RB104-09/10

R602.7, R602.7.1 (New), Table R602.7.1 (New), Figures R602.7.1(1)-(2) (New)

Proposed Change as Submitted

Proponent: Joseph Lstiburek, Building Science Corporation

FIGURE R602.7.1(1)
SINGLE MEMBER HEADER IN EXTERIOR BEARING WALL

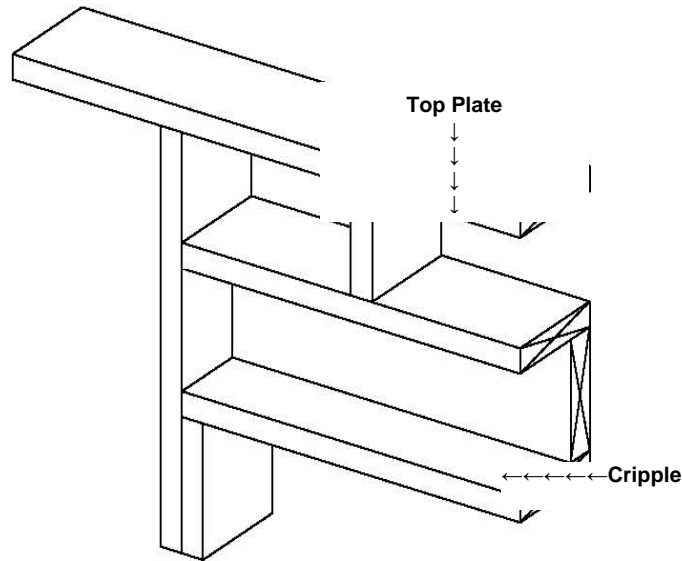
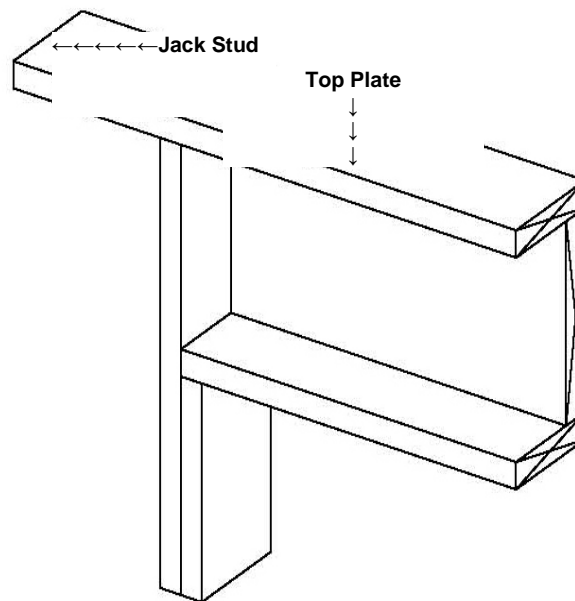
R602.7.1 Single member headers in exterior bearing walls. Single member headers in exterior bearing walls shall be permitted in accordance with Table R602.7.1. Single headers shall be framed top and bottom with a flat-wise 2x member. To make up the remaining space, cripples shall be installed above the header. See Figure R602.7.1(1). Alternatively, the header can be sized to fill the space between the wall top plate and a flat-wise 2x member. See Figure R602.7.1(2). The header assembly shall bear on a minimum of one jack stud at each end.

Reason: This proposal provides a means of implementing advanced, ←←←←← Jack Stud construction practices for limited conditions where single headers can be used. Thus, insulation can be placed together with the single header to prevent heat loss through headers which otherwise create a

**FIGURE R602.10.1.1
BRACED WALL LINES**

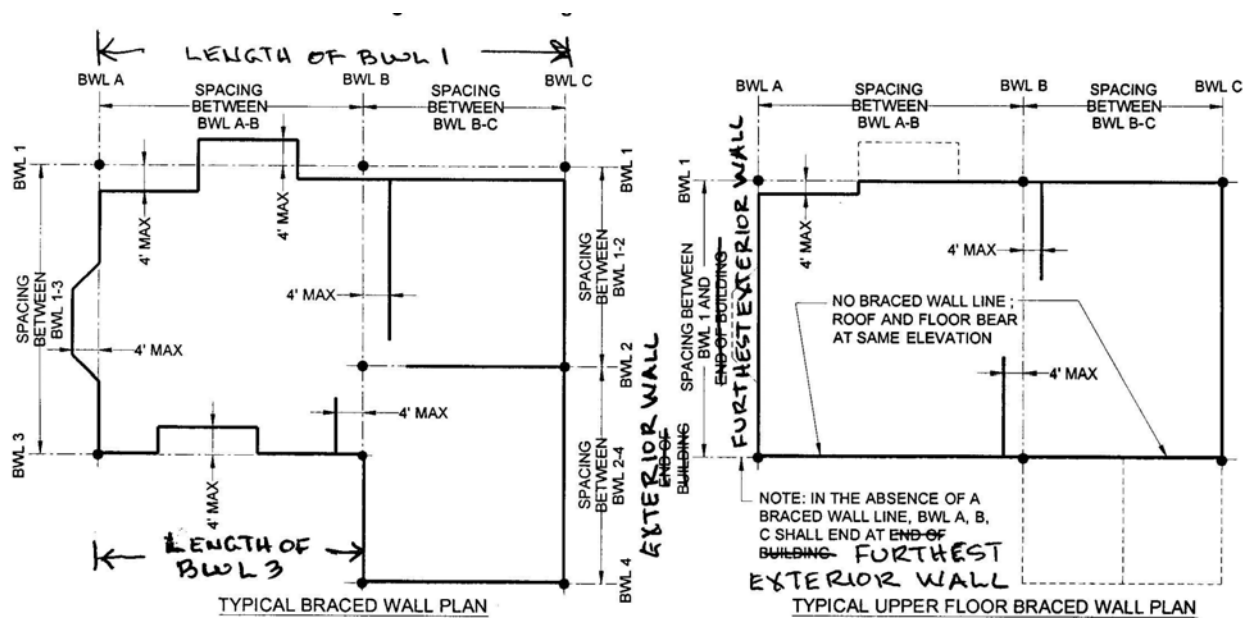
3. Figure R602.10.1.1 is clarified in several ways. First, this figure supposedly goes with Section R602.10.1.1, which describes the length of braced wall lines, but the figure does not say anything about the length of braced wall lines. Two dimensions are added to illustrate choosing the length of braced wall lines. Second, the wording "End of building" is changed to "Exterior Wall" and "Furthest Exterior Wall" to be consistent with the wording in the Section.

R602.10.1.1 Length of a braced wall line. The length of a braced wall line shall be the distance between its ends. The end of a braced wall line shall be the intersection with a perpendicular braced wall line, ~~or an angled braced wall line as permitted in Section R602.10.1.4~~ or an exterior wall. ~~In the absence of an intersecting braced wall line, the end shall be the farthest exterior wall of the building as shown in Figure R602.10.1.1. The end of the braced wall line shall be chosen so that the maximum length results.~~

FIGURE R602.10.6.2(3)
BRACED WALL PANEL CONNECTION OPTION TO PERPENDICULAR RAFTERS OR ROOF TRUSSES

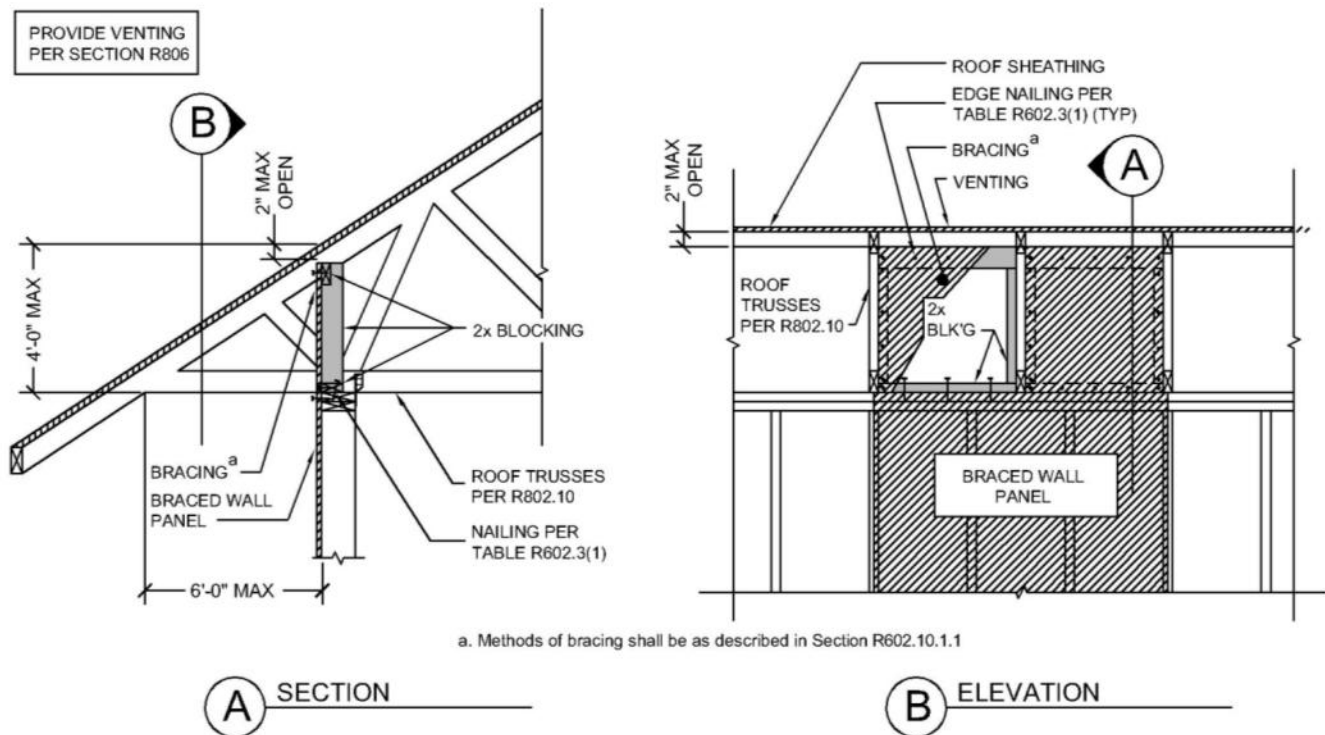
Figures R602.10.6.2(2) and R602.10.6.2(3) are extensively revised. The details are clarified to indicate the blocking panel is only required at the braced wall panels, not along the entire braced wall line. The list of allowable methods is revised to point to Section R602.10.1.1, which includes all the allowable intermittent and continuous bracing methods, including the various alternate narrow wall panels and portal frames. Finally, the reference to "pre-engineered trusses" is replaced with a reference to R802.10, since roof trusses under the IRC are not required to be designed by an engineer.

3. Replace Figure R602.10.6.2(3) with the following:
